Tech Bulletin Ref: 8.13.14

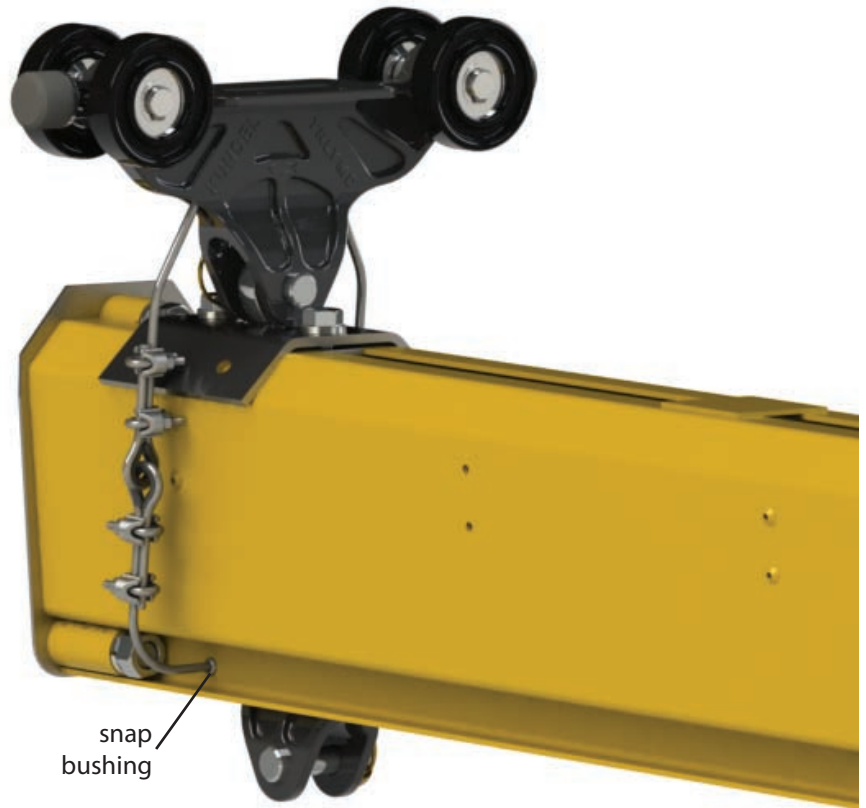
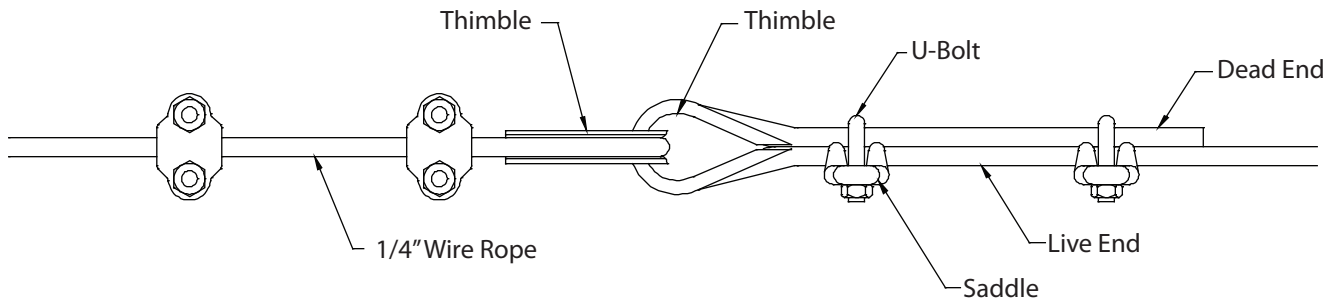
Kundel Industries, Inc. ("Kundel") continuously strives to provide the best products and service in the industry. In our constant effort to improve Kundel products, we have designed and developed a redundant safety attachment mechanism for the bridge assembly of the K-Trac® Crane Series to further enhance its strength, durability and safety. The new attachment mechanism is being provided in a kit which includes the following items listed below for installation as shown in the images to the right.

Note to installer: Make sure that all threaded connections internal or external have been treated with a locking agent such as Loctite®. Small 3/8" holes will need to be drilled thru the rail in order to allow the safety cable to pass thru and then re-attach back onto itself. The cable provided will pass thru the trolley/endtruck body through the designated arc shaped channel immediately above the hook. Please use the snap bushings for each hole drilled.

When assembling wire rope clamps to wire rope be sure the saddle part of the clamp is on the live end of the rope. The u-bolt part of the clamp should be on the dead end or short end of the rope.
